**RE: TLC Plumbing Office/Warehouse
Grading Plan and Drainage Report
Stamp Date: 4/14/17
Hydrology File: G15D032**

*TLC Warehouse & Building
Drainage Management Plan*

TLC Warehouse and Building

TLC OFFICE WAREHOUSE - NORTH BOUNDARY ONSITE SWALE

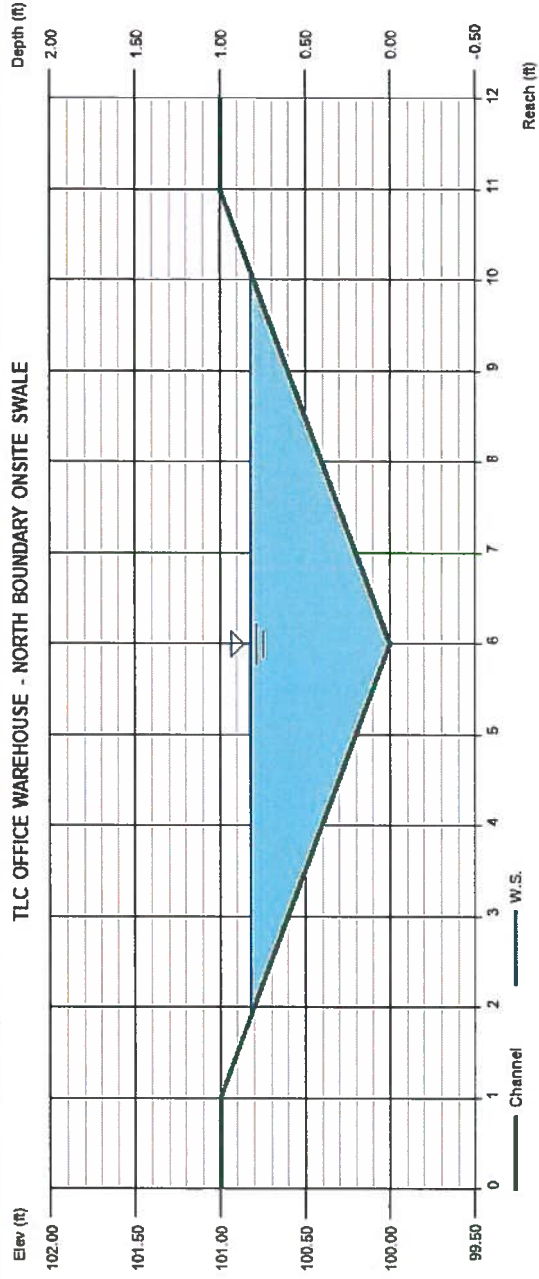
1. Please show a cross section for Sub Basin 100 and label the size and depth of the rock for the drainage swale.

1. As a follow up to our phone conversation, I sent you the as-built for the SAD storm drain in Edith Blvd. All the drawings I could find lack information on what the SAD identification number is. The SAD drainage criteria was taken from a prior approved and as-built grading and drainage plan for this site done by our office. This should also be in the hydrology files under the same name.
2. Refer to Figure 4 for a summary of all the hydrology for this site.
3. The maximum allowable discharge was calculated to be 71.7 cfs based on the 20% Treatment B and 80% Treatment D criteria. The peak developed flow from the entire site was calculated to be 47.5 cfs. This is stated in the report text now.
4. Done.
5. Please refer to Figure 4 and the AHYMO printouts in the appendix.
6. A cross section of the swale that has been shifted to the north boundary is now show on the plan.

TLC WAREHOUSE GRADING DRAINAGE PLAN

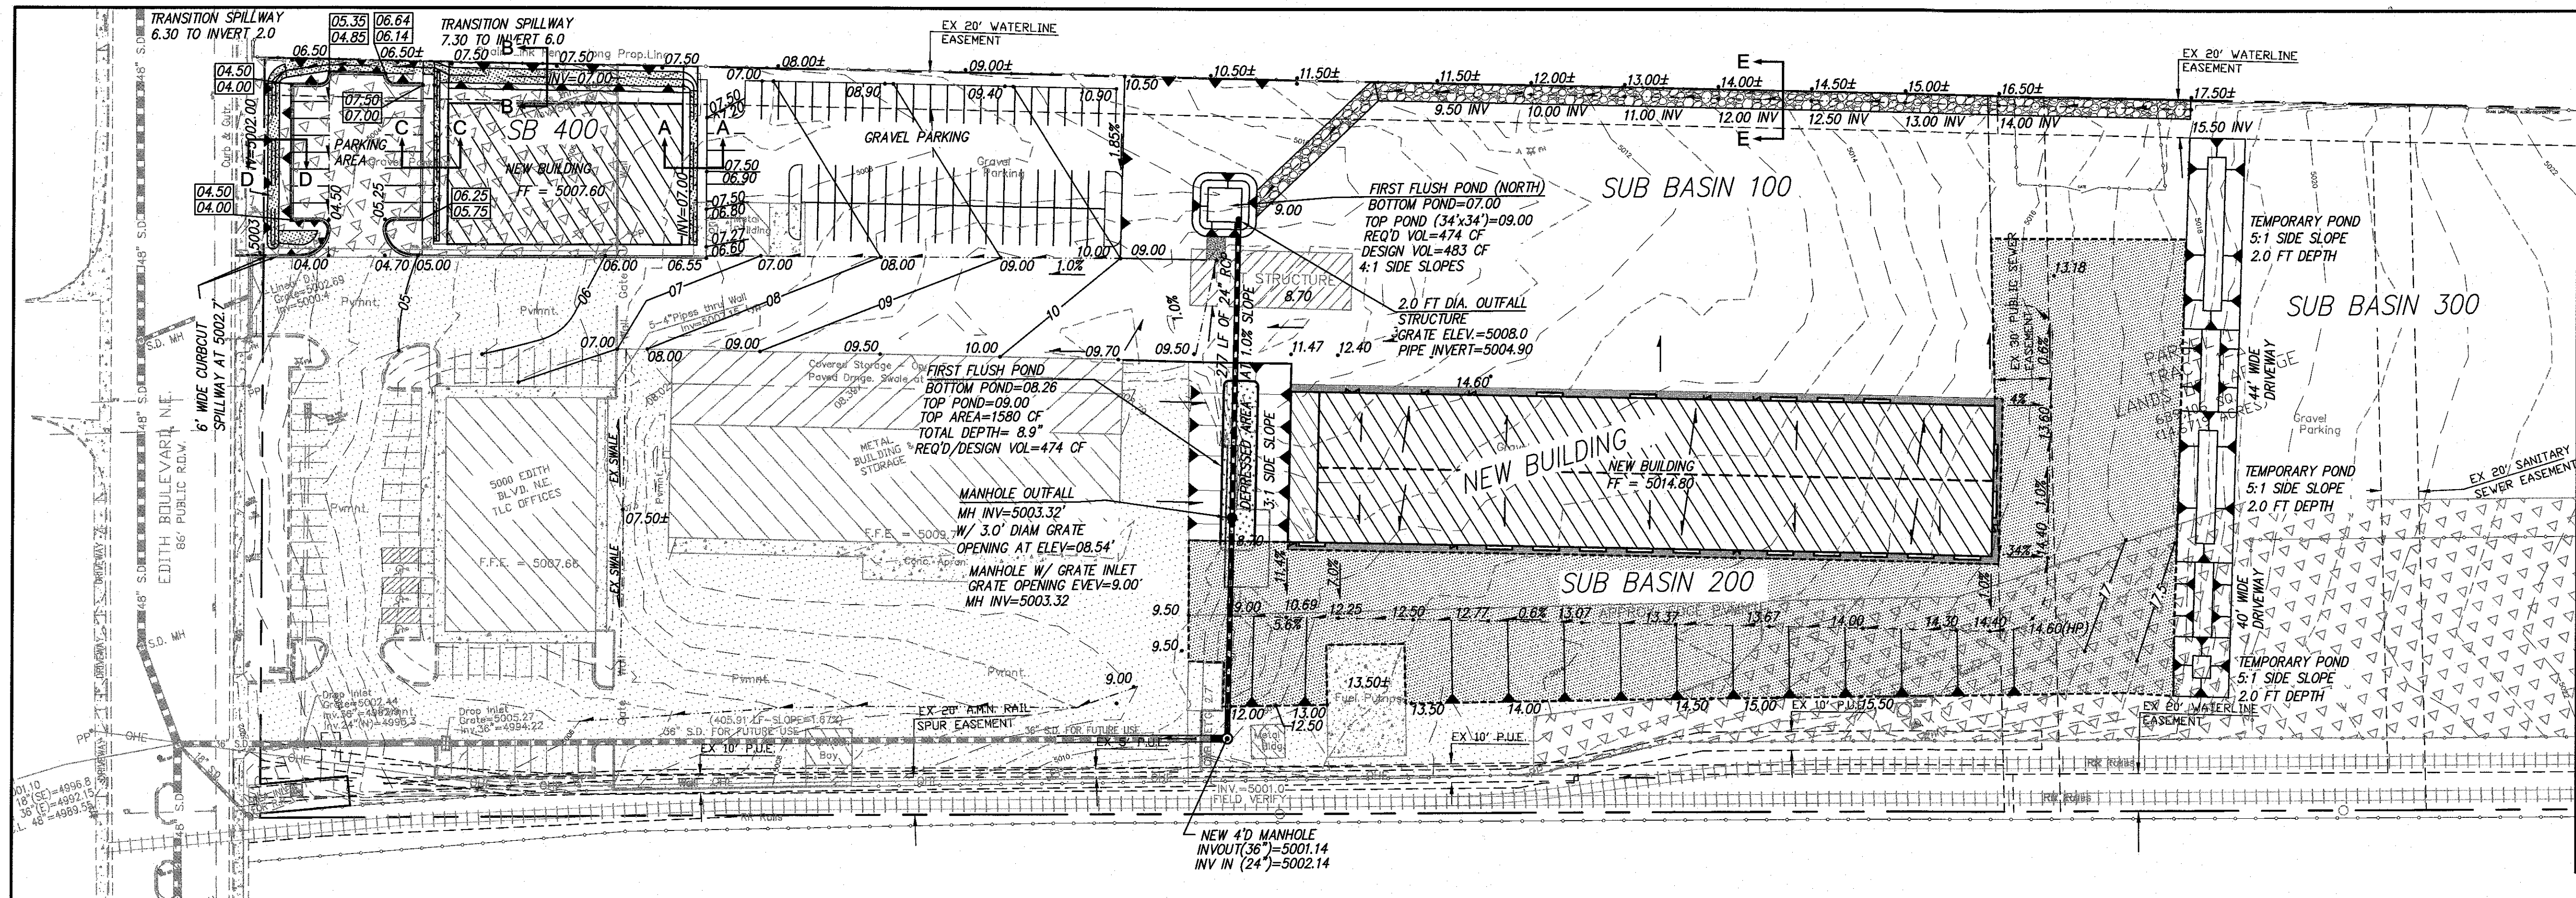
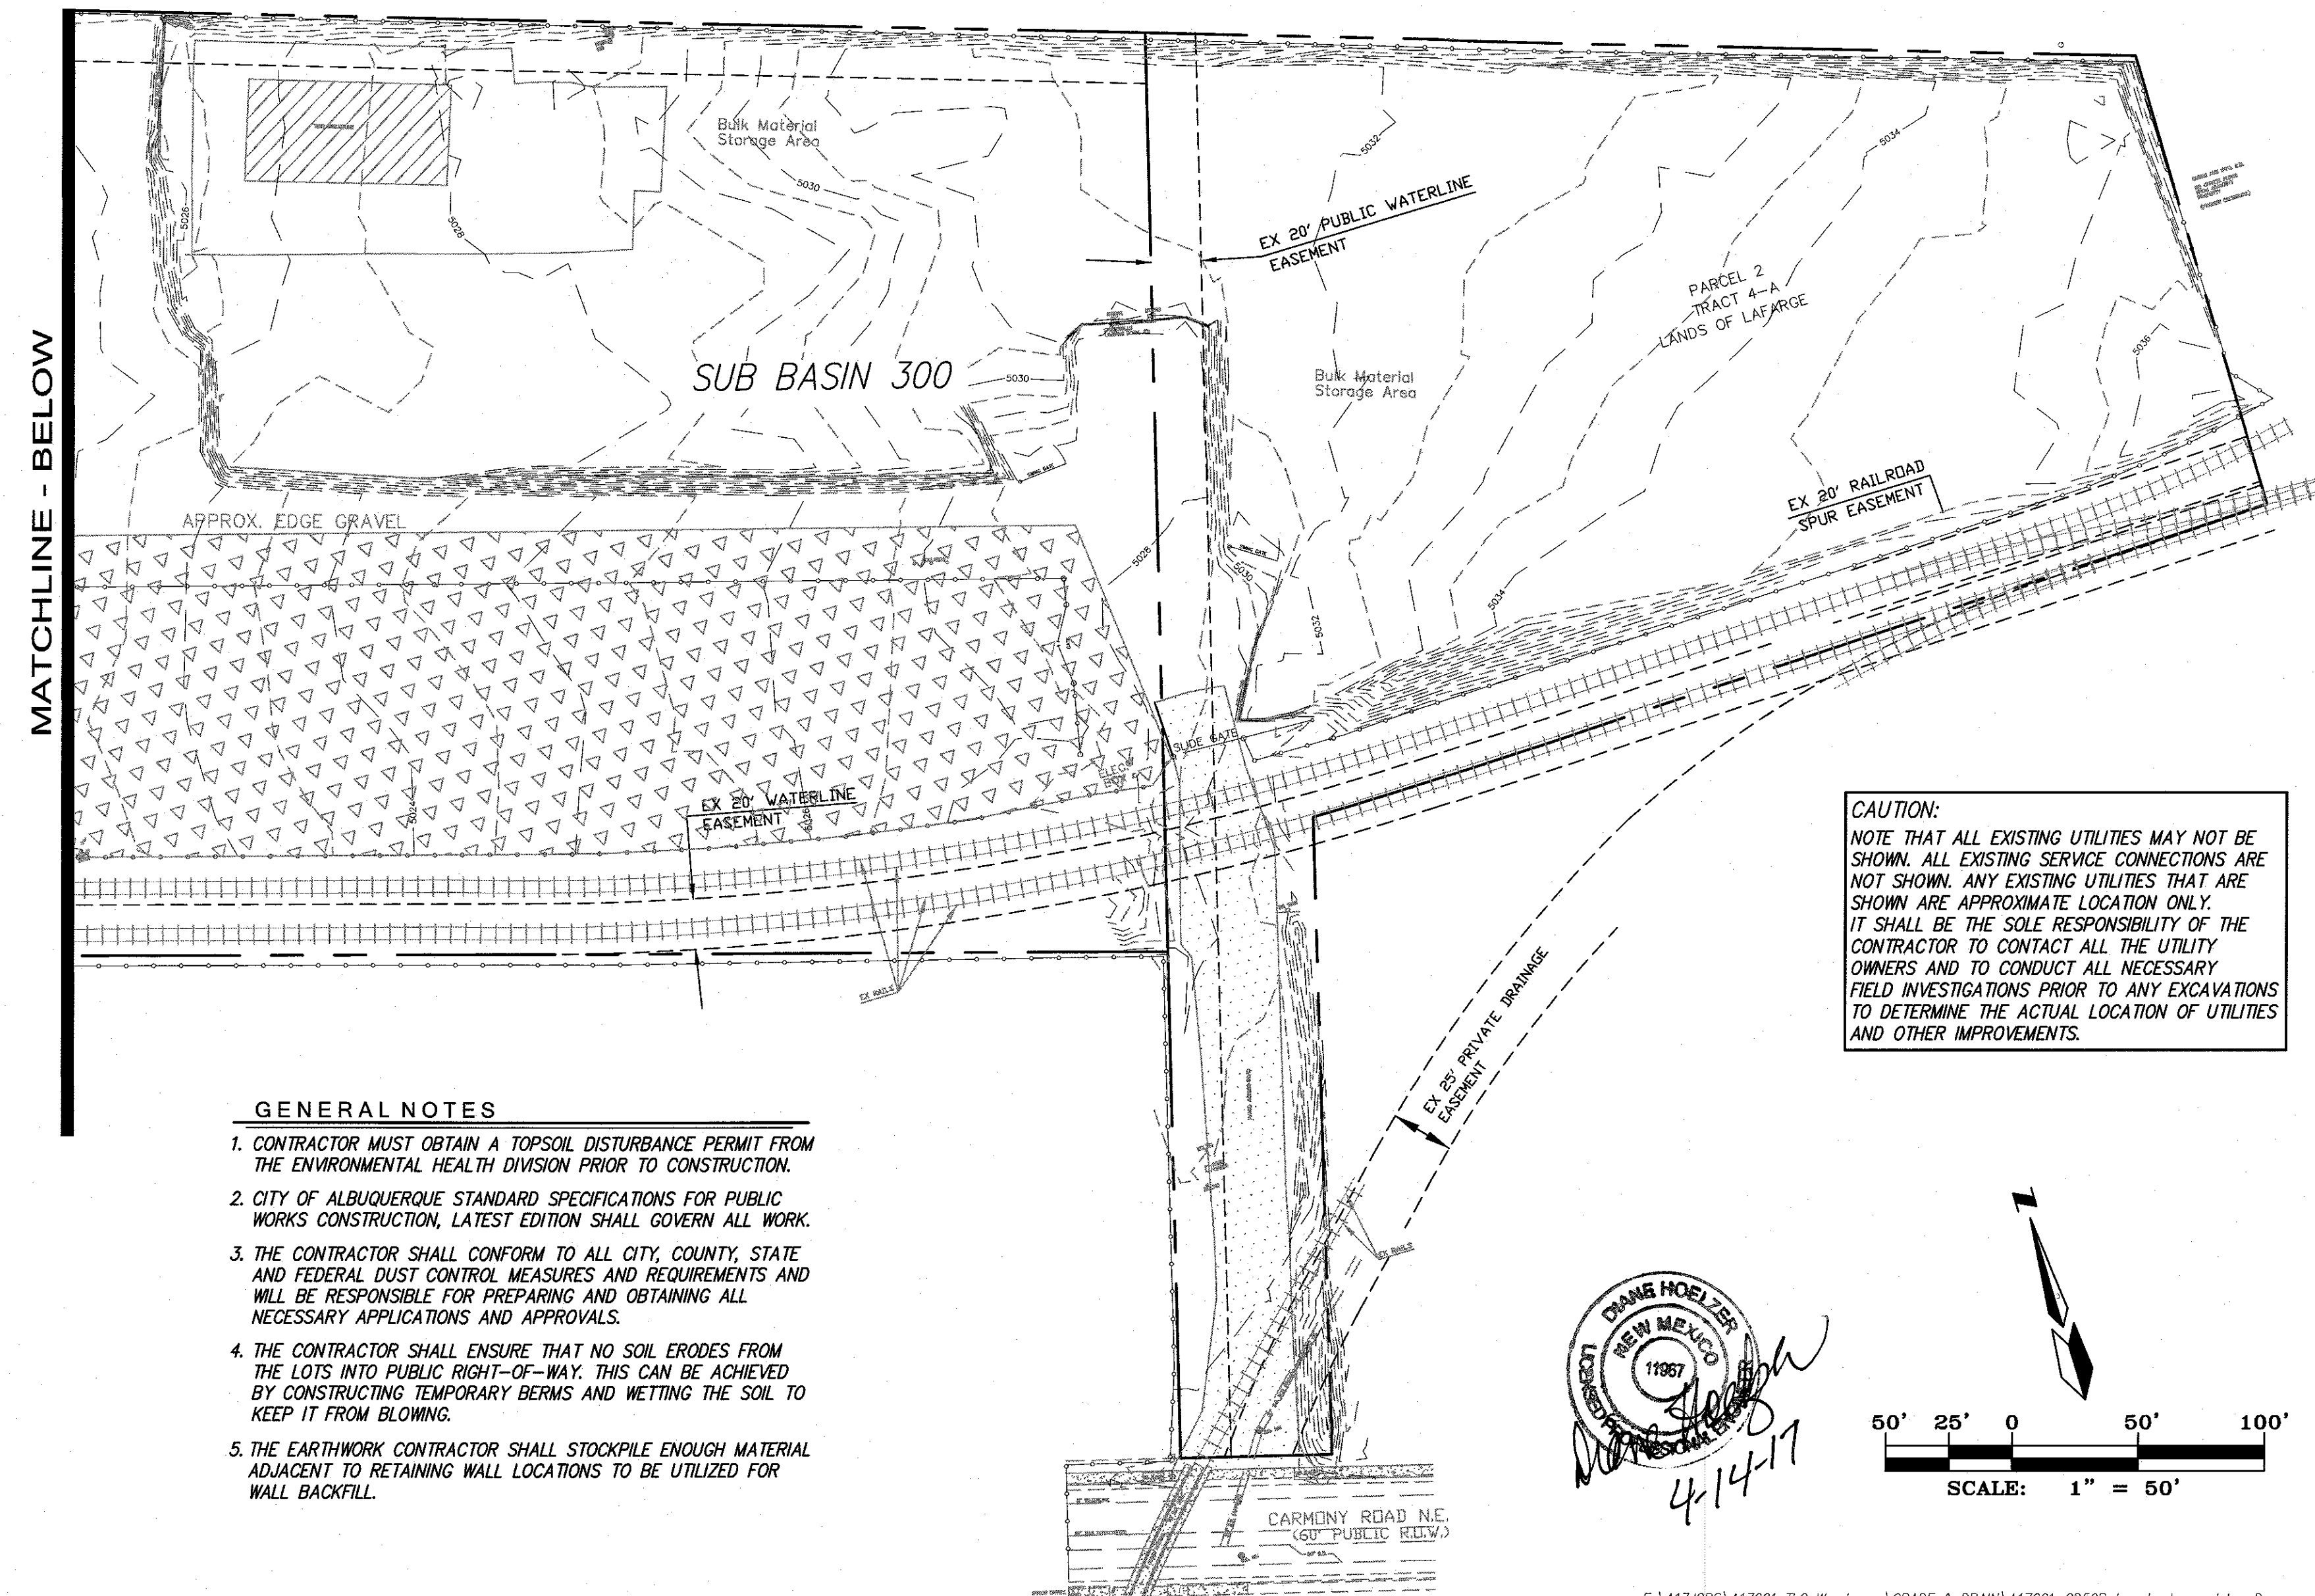
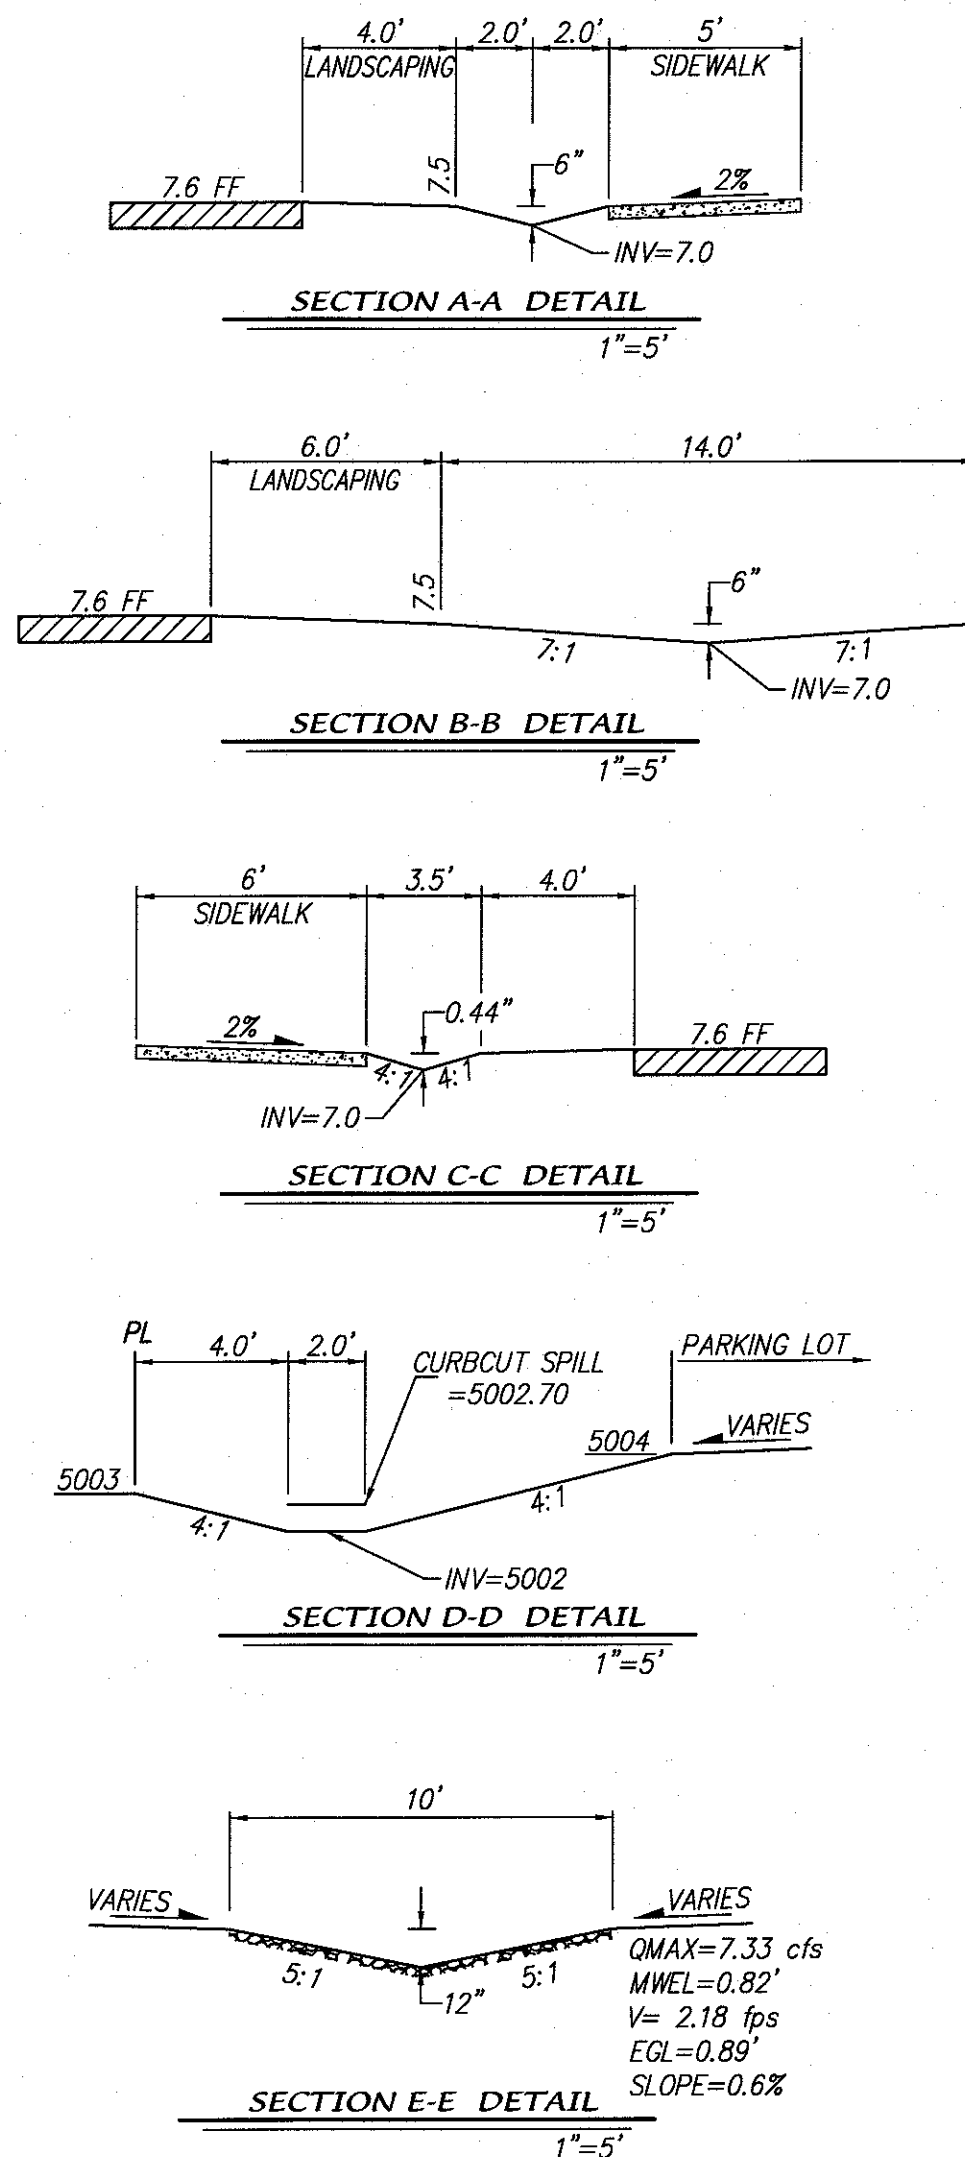
This is fine for the storm in Edith, I will add this to the file. If you can show that the peak discharge for the whole 17.145 ac site with the proposed development is under the existing peak discharge of 71.7 cfs and the minor change on the grading plan (showing the section for the rock swale). I can approve the project.
